COUNTY COUNCIL'S RESPONSE TO CONSULTATION ON THE FOLLOWING DEVELOPMENT PROPOSAL

Application no: 25/01510/OUT

Proposal: Outline planning application for the erection of up to 500 dwellings and commercial floorspace (Use Class E) with associated access, open space and infrastructure - All Matters Reserved except for Access.

Location: Land South Of Perdiswell Farm, Shipton Road, Shipton On Cherwell

A4095 Access Roundabout

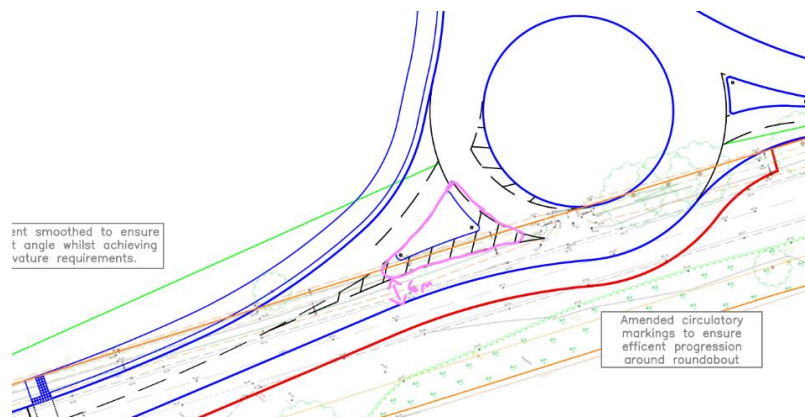
The Proposed Site Access Drawing has been amended. Drawing 23570-05-GA3 Rev E now only shows the standalone toucan crossing on the A4095 Upper Campsfield Road southern arm, approximately 75 metres from the roundabout. The uncontrolled crossings at the roundabout over the A4095 arms have been removed. An additional uncontrolled crossing has been included approximately 150m north of the roundabout to connect to the PROW on the east side of the road.

It was noticed that the design speed of the proposed roundabout is 70kph, which is 40mph and the stopping sight distance is based on this. However, the applicant have

not stated anywhere that they will reduce the road speeds. The stopping sight distance for 60mph is 215m. The visibility for the new roundabout and the crossings is therefore not in line with DMRB.

The Highway Agreements Team have requested that the hatching is removed on the western arm of the proposed roundabout on the A4095 Upper Campfield and the size of the traffic island increased. This is because there is a risk drivers may use the right turning lane to overtake another vehicle when they realise that they can drive over the hatched area. The exit width needs to be similar width or narrower than the entry width.

The applicant needs to explain why the circulatory width is being reduced with hatching.

The Highway Agreements Team have requested that white lining is added to the circulatory carriageway of the proposed roundabout as this will help direct drivers into the correct lanes. Arrows on the lanes are also required.

Figure 3.8.1W1 Turning widths required for compact or smaller normal roundabouts

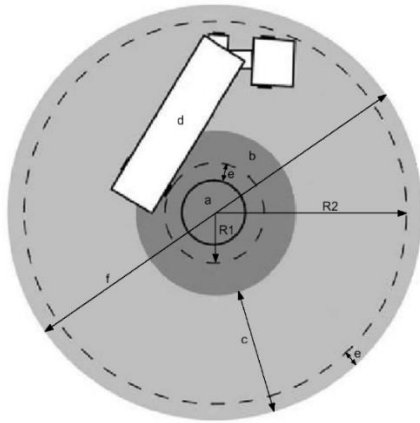
The Highway Agreements Team have also request to demonstrate that a 16.5m Articulated lorry can go all around the proposed roundabout similar to the below extract.

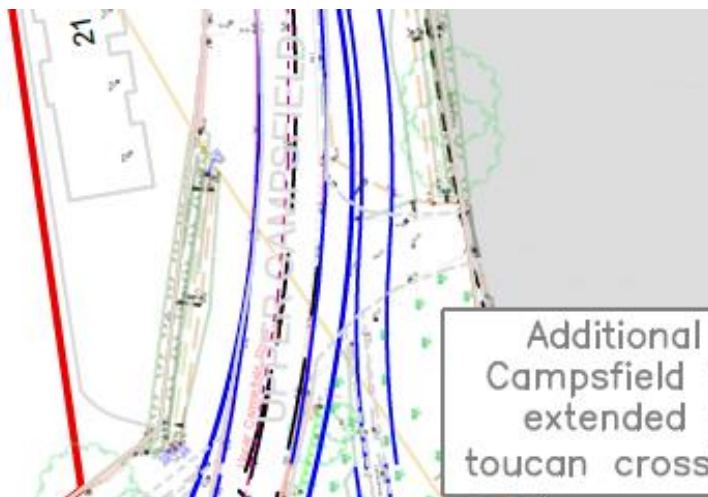
The updated drawing now shows the topographical survey. It was noticed that there is a field access close to the roundabout. This site will become a Park & Ride and it is assumed that the access would be closed off then, but this might be a number of years away. For the interim period, the applicant needs to include this access in the drawing and demonstrate how the crossing with the footway /cycleway is achieved.

Figure 1 Route to Marlborough School

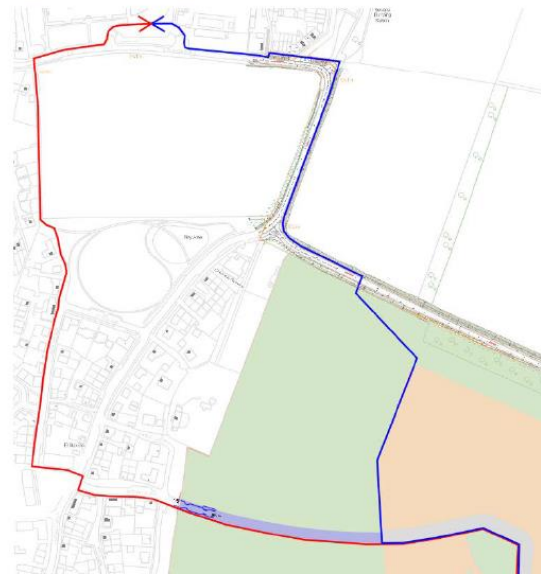
Paragraph 2.8 of the TAA states that an assessment of the routes between the development and the schools has been undertaken with reference to LTN 1/20 design principles. However, the Active Travel Audit undertaken by the applicant, also submitted in December, has reviewed connections shown on the left while the proposed route to the secondary school in the TAA is reproduced on the right. This shows that only a very small section of the red route has been assessed.

Paragraph 6.1.9 of the Active Travel Audit states: *“Route 1a (Shipton Road between Park View and Randolph Avenue) scores below the minimum threshold; however, this route is not relied upon as a primary pedestrian route to key destinations from the proposed development. The principal pedestrian desire lines to Woodstock town centre, local facilities and education are via the Park View development and the A44 Oxford Road, which achieve scores comfortably in excess of the minimum requirement.”*

This is unacceptable, route 1a is the most direct route from the application site to the secondary school, especially for dwellings in the northwest of the site.

The proposed link shown in the TAA is not a Public Right of Way or within adopted public highway. Although it has been included in the original Park View Access and Movement Parameter Plan, it is now understood that this land is not in the ownership of the park View applicants and they are not in a position to deliver the connection.

A connection at the north west corner of the application site to Shipton Road is therefore required and the submitted Access and Movement Parameter Plan needs to be amended to include this connection.
